To: T10 Membership
From: Lawrence J. Lamers, Vincent Bastiani
Subject: Groundwork for Expander Communication
Date: Wednesday, March 31, 1999

This proposal lays the groundwork for expander communication in the next version of SPI. It does this by providing a minimum pulse width for asynchronous non-data transfers

Minimum pulse width Target to Initiator

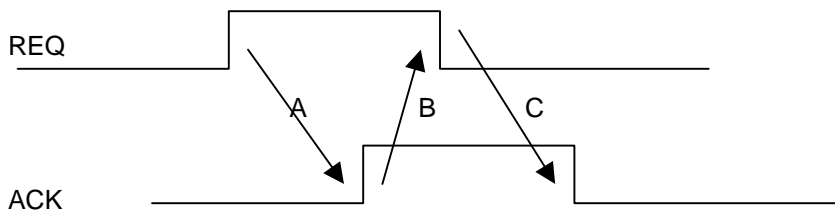
The REQ pulse width in asynchronous transfer when data is moving from the target to the initiator is determined by the time it takes for the initiator to respond with the assertion of ACK.

The assertion edge of ACK is triggered by the assertion edge of REQ (Time A). The negation edge of REQ is triggered by the assertion edge of ACK (Time B) and the negation edge of ACK is triggered by the initiator seeing the negation of REQ (Time C).

Times B and C could be combinatorial in nature. Time A is not combinatorial since the initiator looks at the data before deciding what to do and hence there is logic involved. If a synchronizer is used the minimum time is two clocks or 50 ns for time A. The duration of A is the most important element in determining the minimum length of REQ in an asynchronous cycle. If the receiving device is slow returning ACK then REQ is asserted and the data valid for that duration.

However if the assumption is made that A, B, C are all combinatorial the minimum REQ pulse that could be produced on bus of zero length is:

Assert REQ → 0 ns → 1.5 ns → 0.7 ns → 3.2 ns → 0 ns → 1.5 ns → 0.7 ns → 3.2 ns = 10.8 ns.

The proposal is to specify a minimum REQ assertion to ACK assertion period of 50ns on data transfers to the host; and a minimum ACK assertion period of 50ns with data being valid until ACK is negated on data transfers to the target.

Minimum pulse width Initiator to Target

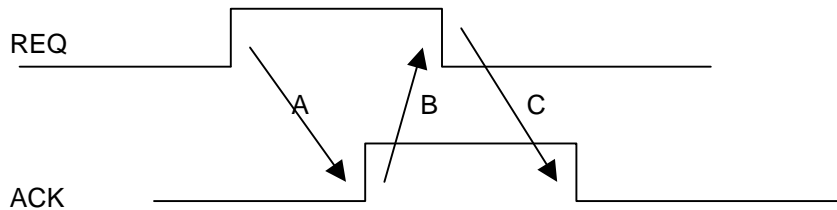
The REQ pulse width in asynchronous transfer when data is moving from the initiator to the target is determined by the time it takes for the target to respond with the negation of REQ.

The assertion edge of ACK is triggered by the assertion edge of REQ (Time A). The negation edge of REQ is triggered by the assertion edge of ACK (Time B) and the negation edge of ACK is triggered by the initiator seeing the negation of REQ (Time C).

Times B and C could be combinatorial in nature. Time A is not combinatorial since the initiator asserts the data before asserting ACK. The duration of A is not important in determining the data valid time. If the target is slow deasserting REQ then the data is valid for the duration of ACK and REQ asserted.

However if the assumption is made that B and C are combinatorial and that data is valid for the duration of ACK then the minimum data valid pulse that could be produced on bus of zero length is:

Assert ACK → 0 ns → 1.5 ns → 0.7 ns → 3.2 ns → 0 ns → 1.5 ns → 0.7 ns → 3.2 ns = 10.8 ns.
